ATTACHMENT 3

**RESPONSE TO MOECC COMMENTS
RE: LEVEL 1 AND LEVEL 2
HYDROGEOLOGICAL INVESTIGATION REPORT,
PROPOSED FREYMOND QUARRY**

April 3, 2018
MTE File No.: C33886-100

**Response to MOECC Comments
Re: Level 1 and Level 2 Hydrogeological Investigation Report,
Proposed Freymond Quarry**

Operation Plan Schematic

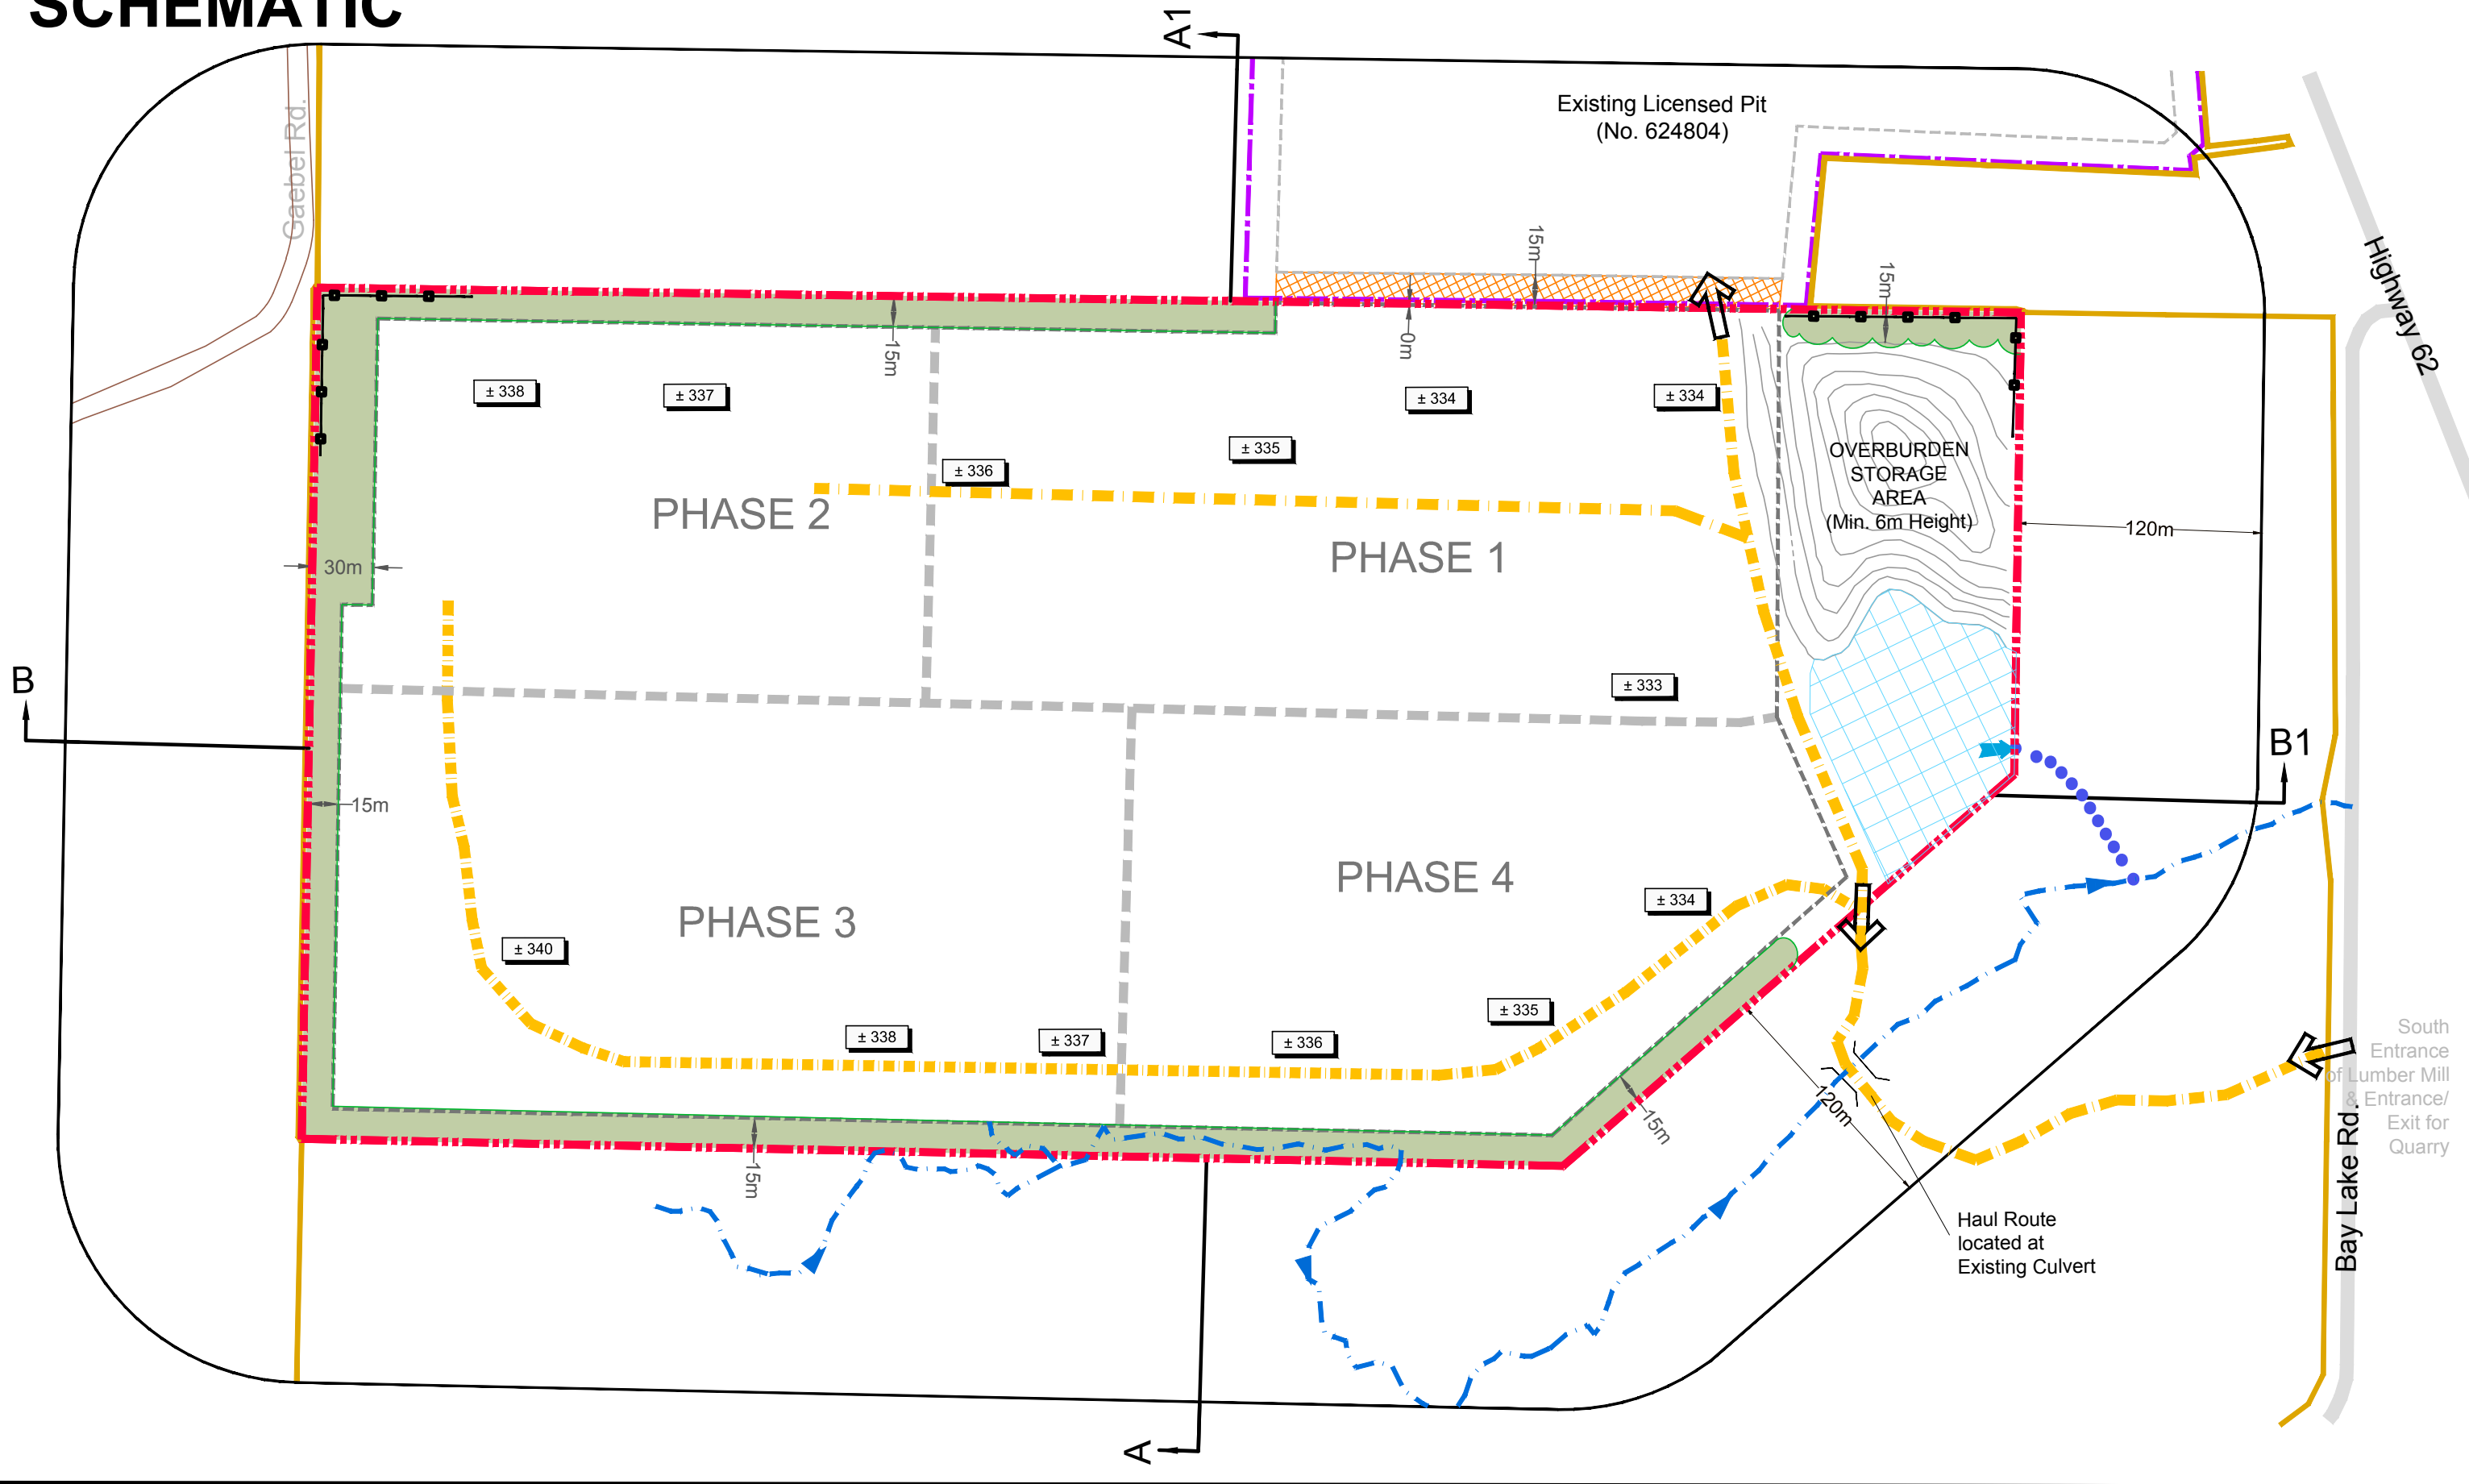
DECEMBER 2016 VERSION OF SITE PLANS UPDATED APRIL 2018 TO SHOW UPDATED LOCATION OF SOUTH STREAM

Based on the setbacks as indicated on the Operational Site Plans (**Attachment 1**) the main branch of the South Stream will remain intact throughout and post extraction (**Figure 1**). Following the extraction of Phase 3, any flow originating within Phase 3 will no longer contribute to the main branch of the South Stream and instead will be directed toward the SWM Facility and will ultimately flow back into the South Stream. Water originating at the headwaters of SW1 will continue to flow downstream to SW5.
